**Radio Communications System Infrastructure Upgrade**  
**Project No. 17PD01**

**Bid Addendum #4**

**November 14, 2017**

## Ayer Bid Questions and Responses

Location of 8' utility ground rods to concrete communications shelter

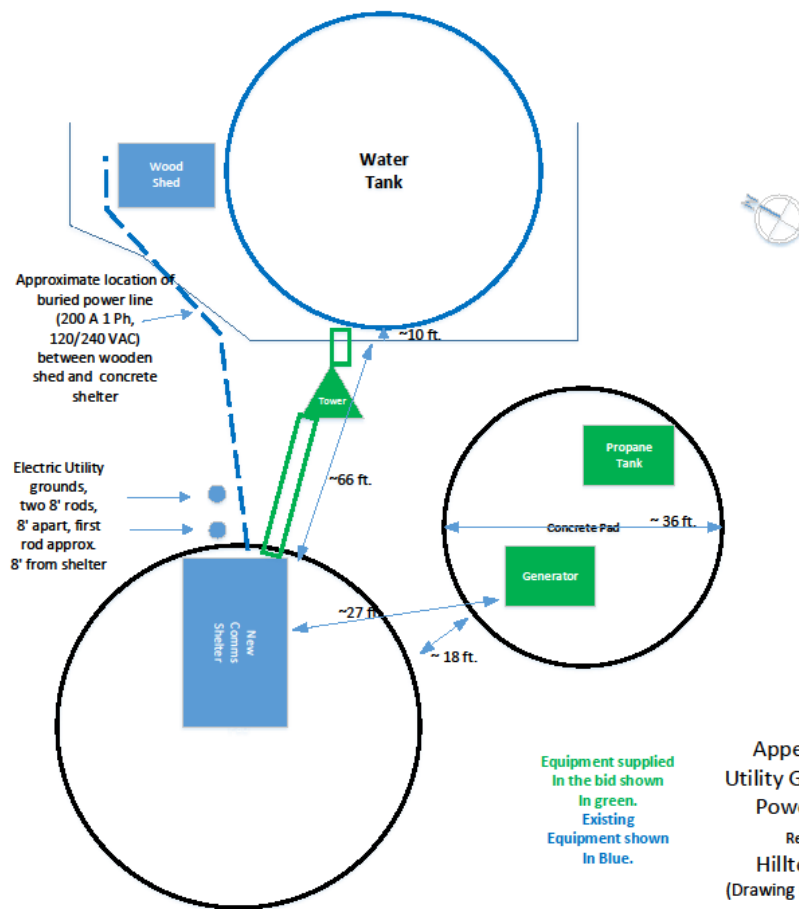
8. Is there existing as-builts for the grounding system and utilities for this site and are they in a digital format?

There is no site grounding system at present; bidders are to include one per the Technical Specifications. When power was provided to the site, two 8 foot ground rods were driven in front of the utility entrance to the shelter, and the location is marked with two plastic conduits. Some photos and a plot plan with the approximate locations are attached herein.

- C. Utility ground rods at the Hilltop site: one is approx. 13.5 feet in front of the shelter, the other is another 12 feet beyond the first one.
- D. Bidders requested GPS coordinates for the monopole locations. Please use the coordinates given in Appendix B.

Re Bidder #2 Question 8 on existing site ground and utilities for Hilltop Site:  
Pictures of the utility ground rod locations and utilities and a plot plan for same are below.

CRABTREE DEVELOPMENT  
 AYER WATER TANK  
**VALVE CONTROL BUILDING**

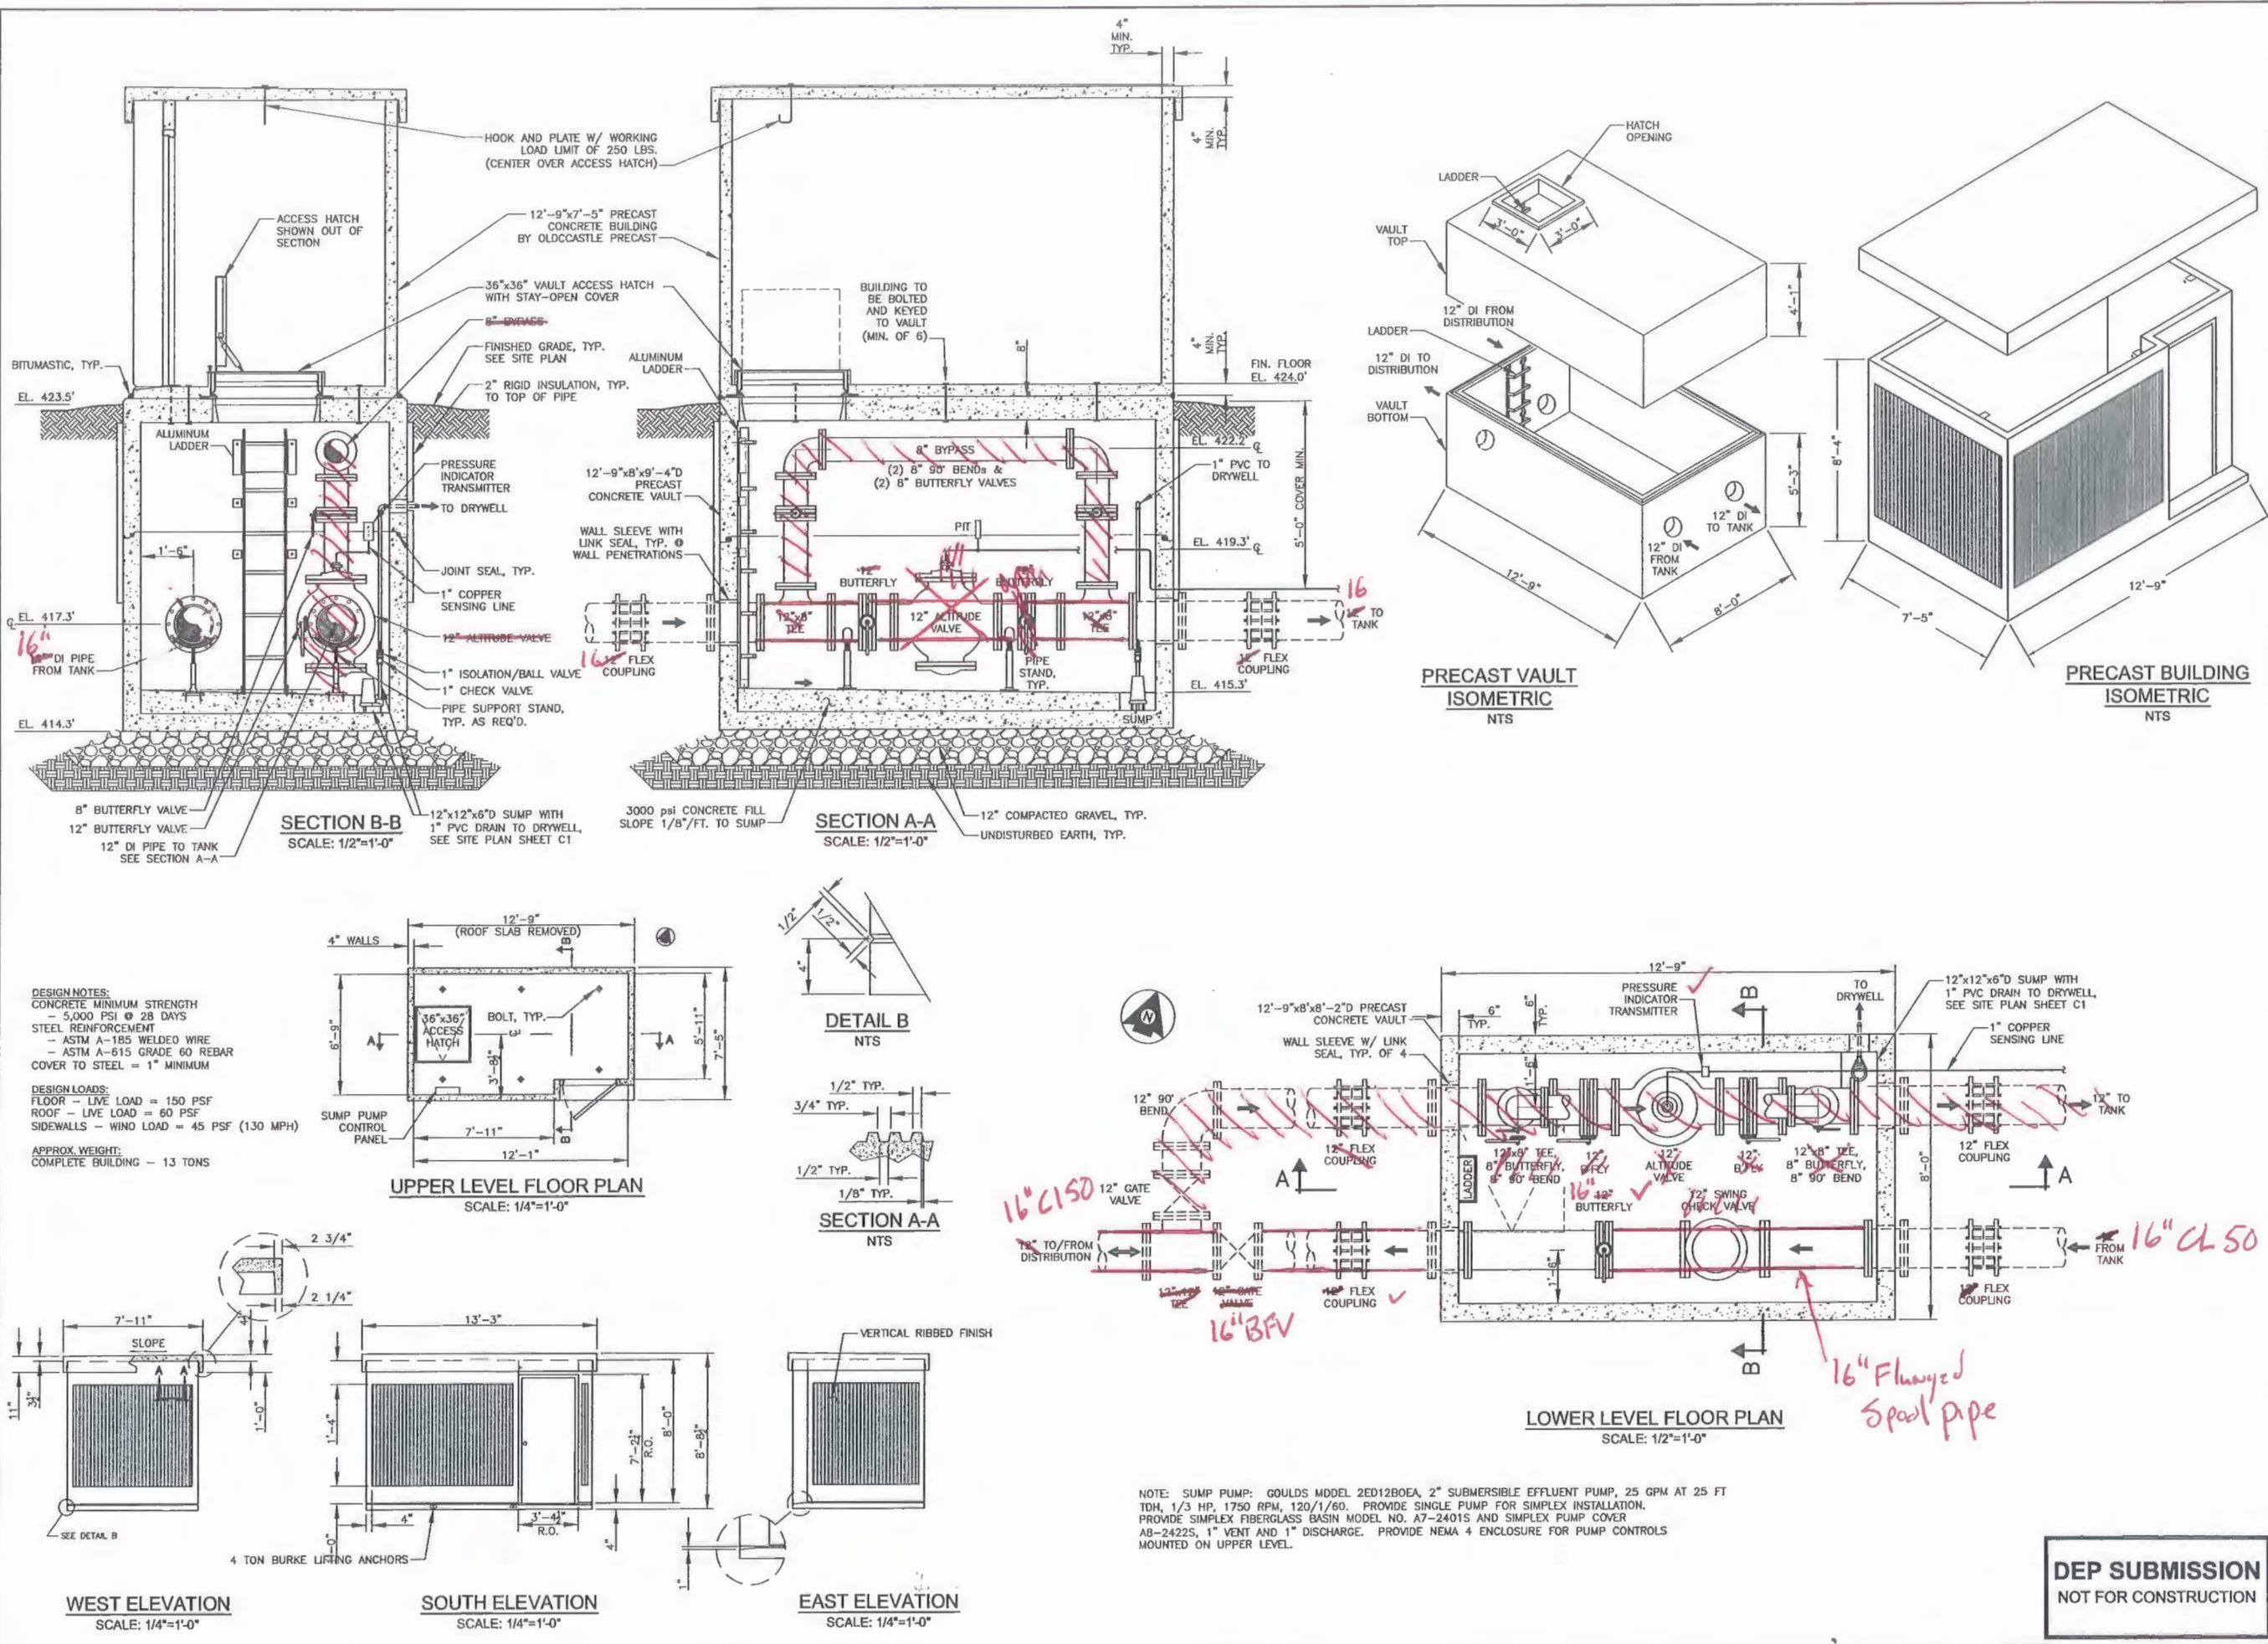
3. Is there existing as-builts for the grounding system and utilities for this site and are they in a digital format?

A: As-builts for the East Receiver site are attached herein.

**SITE PLAN**

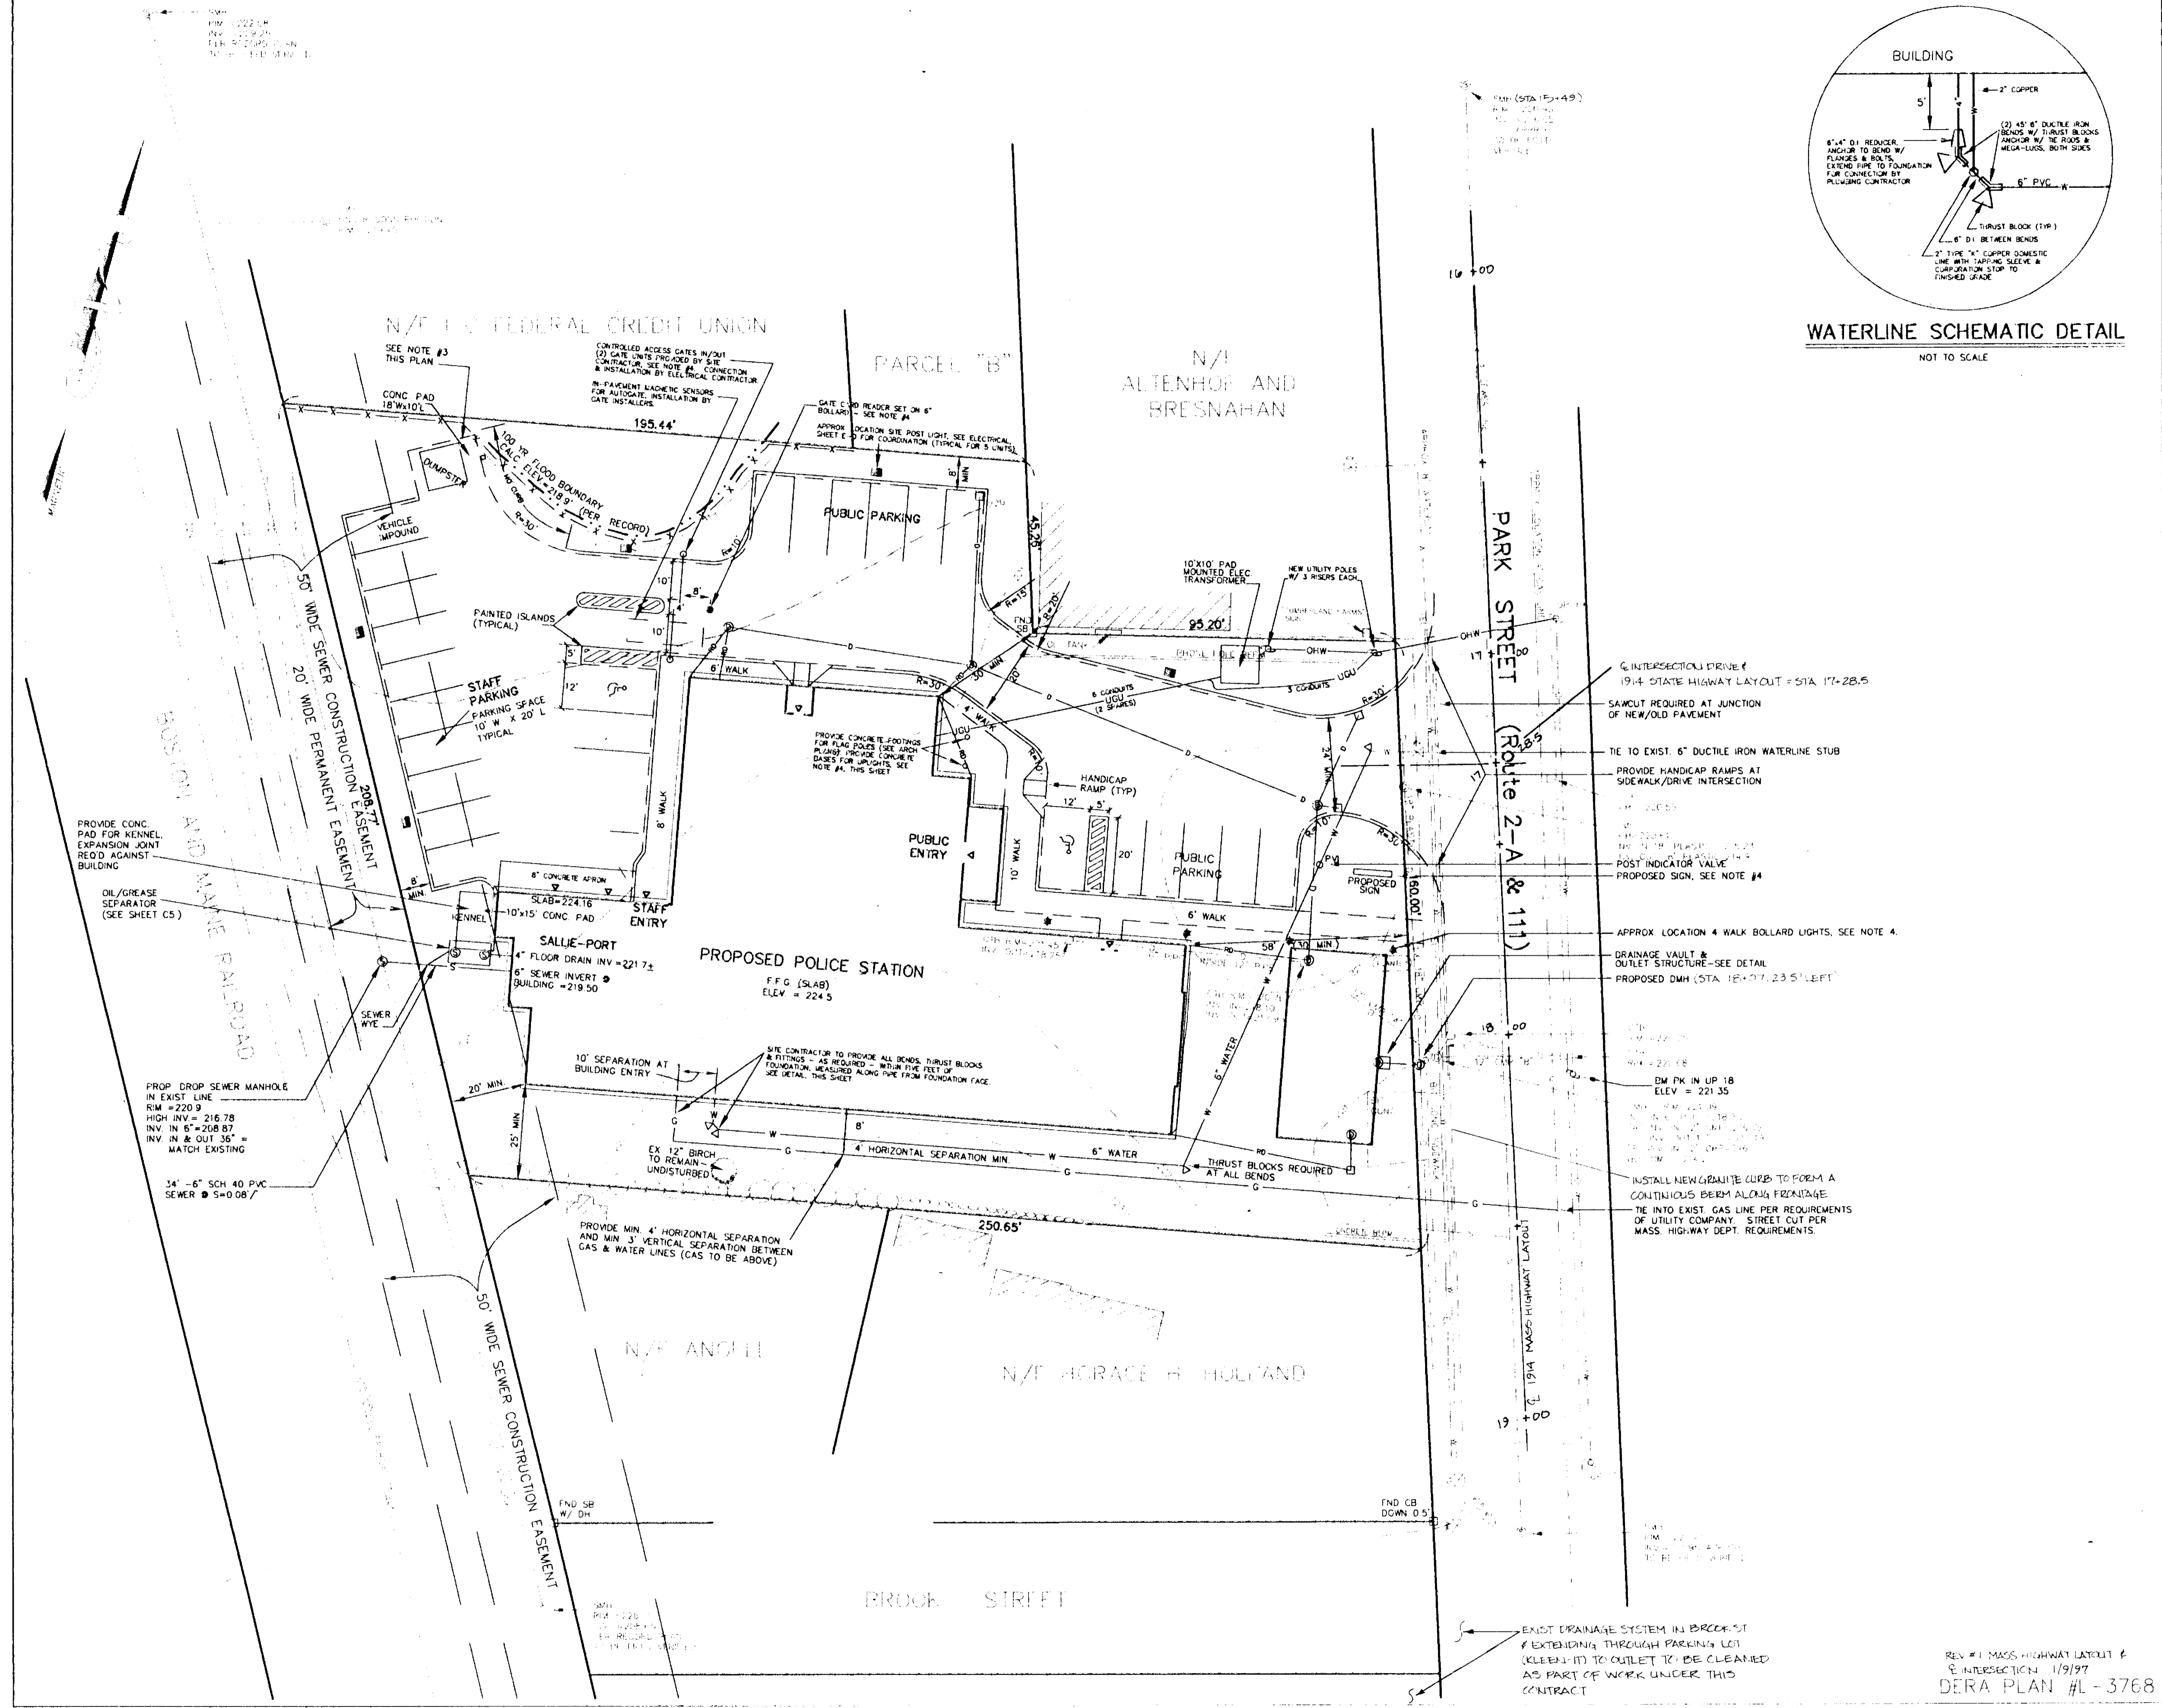
4. Does the town have a site plan for the PDHQ to identify the utilities / sewer drain pipes?

3. Is there existing as-builts for the grounding system and utilities for this site and are they in a digital format?

A: Site Plan is attached.

A: Site Plan attached.
